# DESIGN ALERT

## DESIGN ALERT INDEX - CURRENT

Design Alert Number	Issue Date	Subject	Verify or Modify Date
003C2B-DA-149	10-01-2018	Patient Privacy and Women Veterans' Health, Design for	
003C2B-DA-148	06-01-2017	VA Standards Application and User Design Input Requirements	
003C2B-DA-147	09-01-2016	VA Project Design Principles – Foundation of Design	
003C2B-DA-144	06-01-2015	Revisions to Telecommunications Systems Uninterruptable Power Supply Requirements	
003C2B-DA-142	06-01-2014	For Immediate Application on All Current Projects Patient Safety in VHA Bathrooms	11-01-2014
003C2B-DA-138	04-19-2012	Indoor Water Features, Decorative Fountains Recommend Non-Use	
003C2B-DA-132	05-01-2008	Pharmacy Design Guidance, Update on Compliance with USP 797 "Pharmaceutical Compounding – Sterile Preparations"	
003C2B-DA-121	09-15-2004	Mycobacterial Laboratories – BSL3 Labs Architectural and Engineering Controls Update

CBOC, EXPA1, EXAM ROOM-PATIENT  
ALIGNED CARE TEAM - PLAN

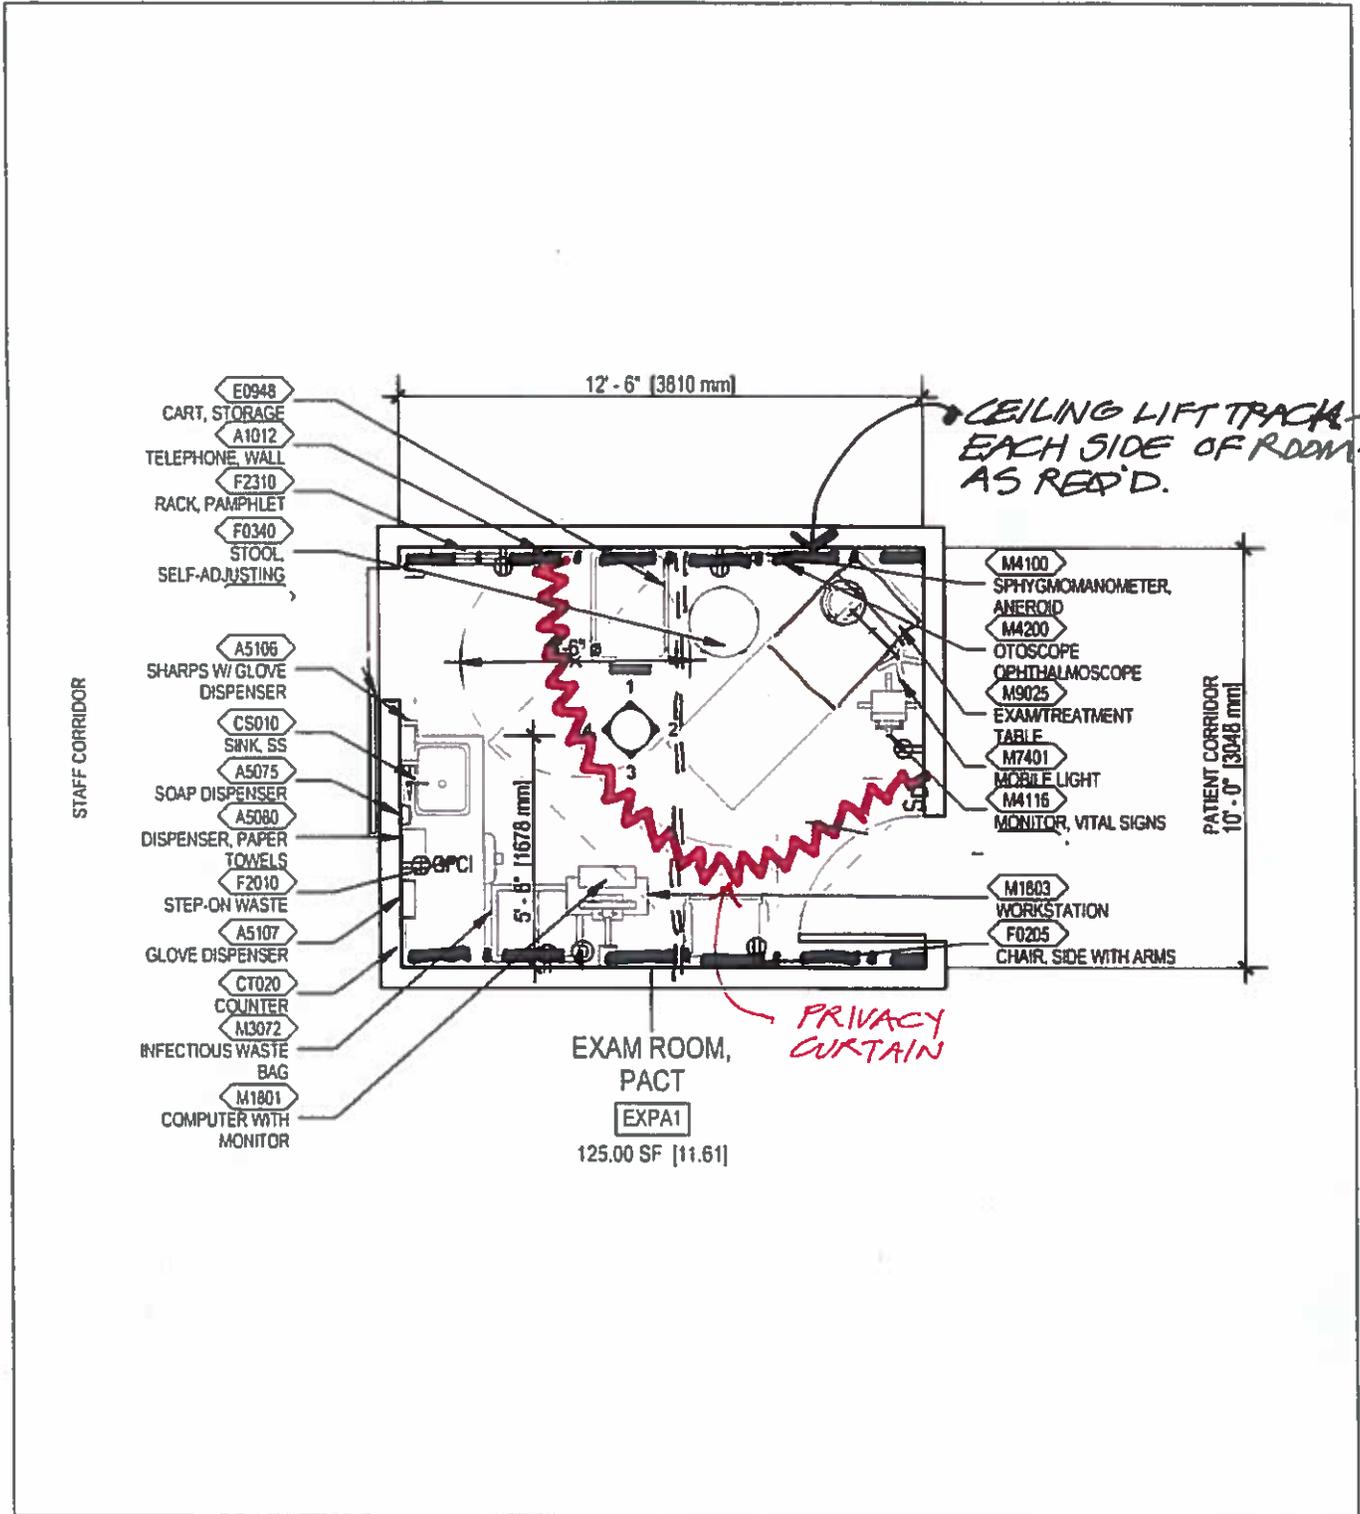
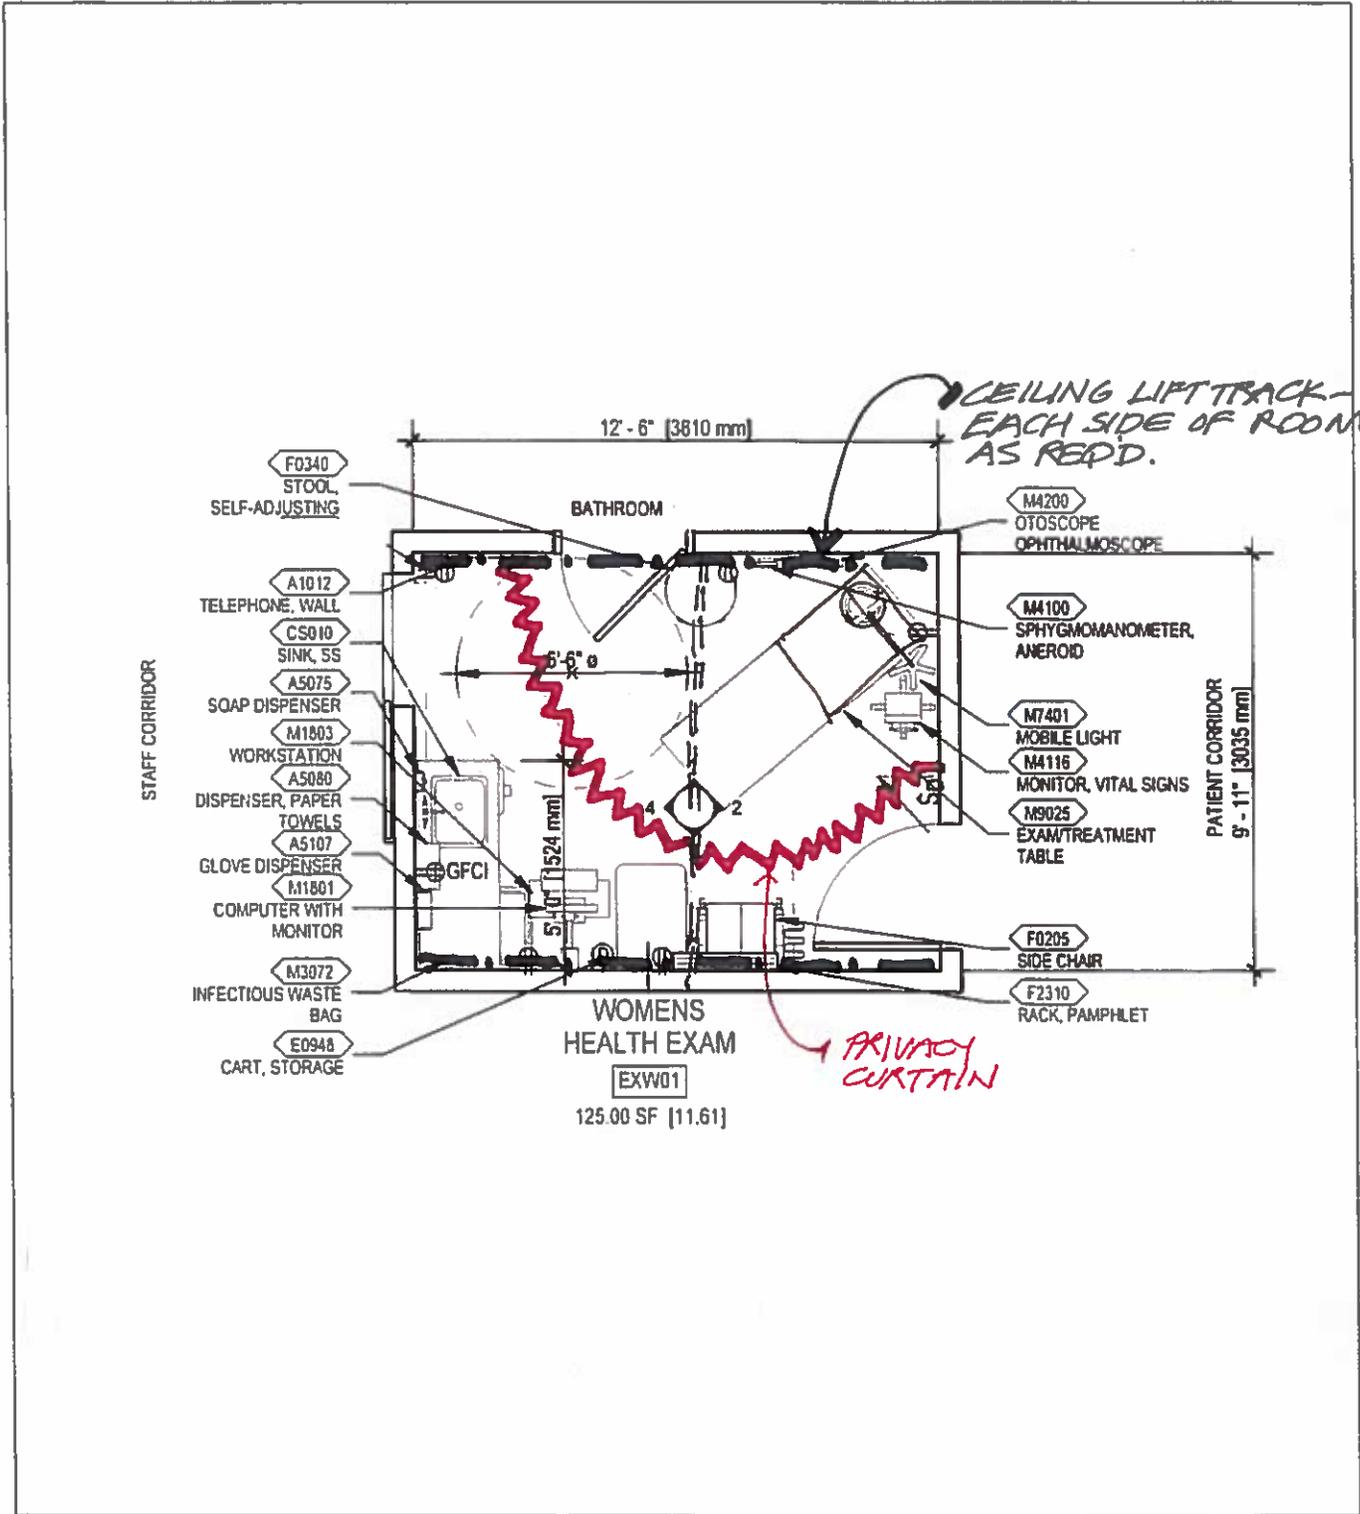
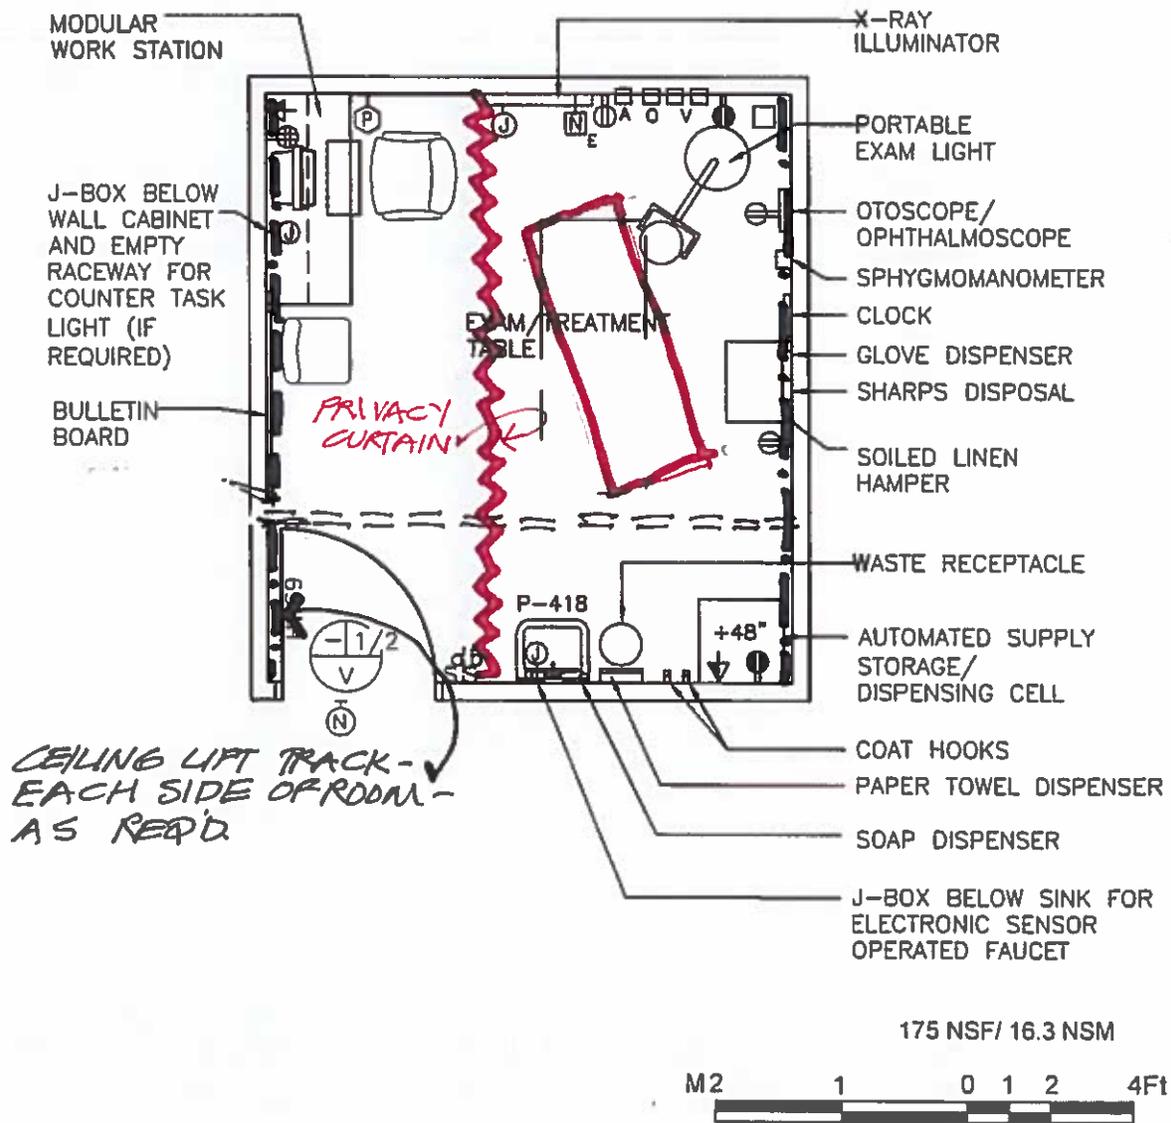
- b) Privacy Curtains / Screens – See attached Room Illustrations. In extenuating conditions, disposable privacy curtains, portable screens, integrated blinds in glass, or other similar systems must be considered. If, due to specific existing conditions or operational requirements, it is not possible to provide a visually private patient changing area, the facility must establish a policy to ensure patient privacy while changing.

- (1) Examination, procedure, and treatment rooms- provide privacy curtains/screens to encompass adequate space for the healthcare provider to perform examination unencumbered by the curtain, and provide a visually private patient changing area that allows the provider to remain in the room.  
Exception: Patient care rooms where a patient does not have potential for exposure of breast or genital areas.

- (2) In-patient rooms (private / semi-private / multi-patient) - Provide privacy curtains to encompass adequate space for healthcare provider to perform bed-side examination unencumbered by the curtain. In these rooms the primary purpose of the bedside curtain is to provide the patient visual privacy from the room entry door during an examination or treatment and secondarily a visually private patient changing area where the provider, or other healthcare staff, can remain in the room.  
Exception: Patient rooms in: Mental Health in-patient units, Intensive Care Units, Recovery, Emergency Departments, dedicated airborne infection isolation rooms, and other rooms with infection control concerns. In these rooms, provide disposable privacy curtains, portable screens, integrated blinds in glass, or other similar systems.

**Subject: Visual Privacy in Waiting Rooms**

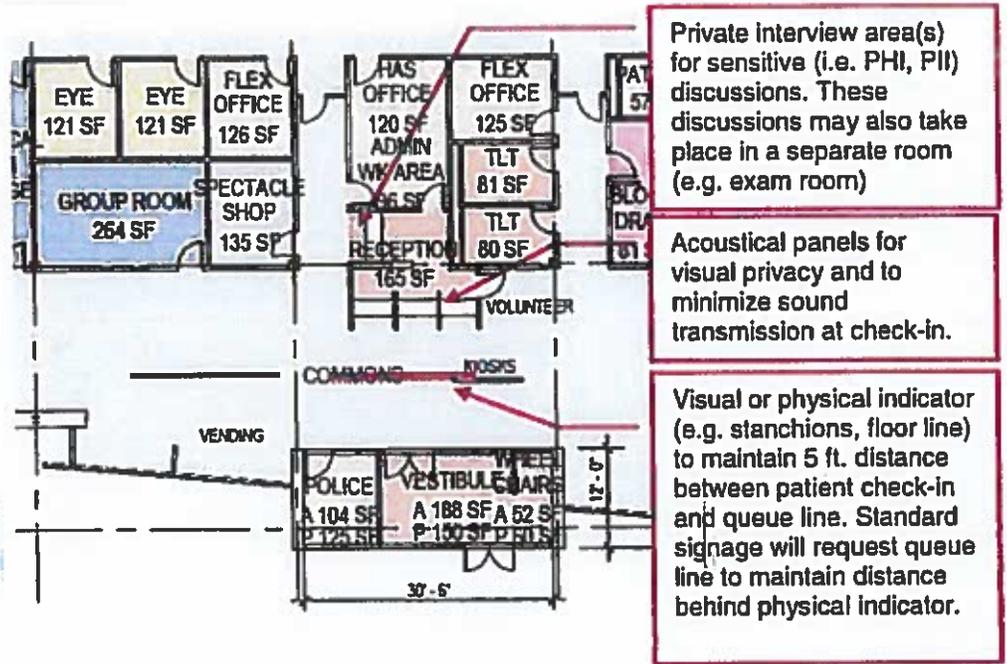
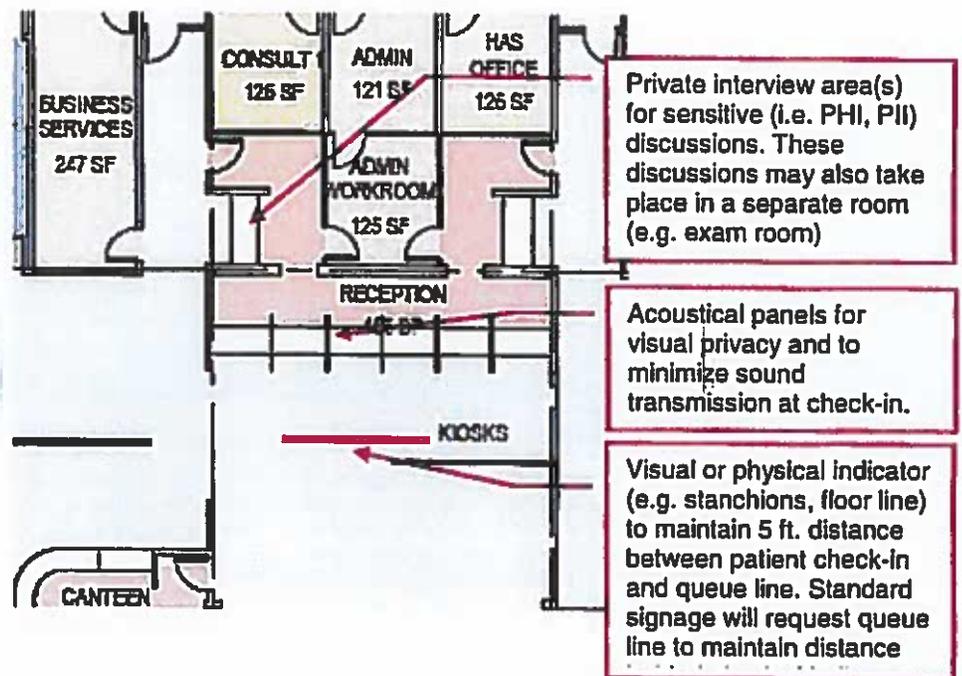
(2) At check-in locations a designated “queue line” is to be marked to provide an identifiable physical distance separation between the person checking in and the

- queue. The minimum distance from the front edge of the Check-in/Reception desk to the queue line shall be five (5) feet.
- (3) Acoustical partitions are to be installed to provide visual privacy at multi-patient check-in counters.
- (4) Provide a private room/area (e.g. private interview room, separate interview station) to accommodate private discussions such as conversations requiring more details than basic patient identification
- 2) Design Guides and Room Templates will be systematically revised to include the requirements of this Design Alert.
- 3) All parties in the planning, design, and construction process must comply with these requirements as fundamental in providing optimum environments for Veterans' care and services, in fulfilling VA's mission.
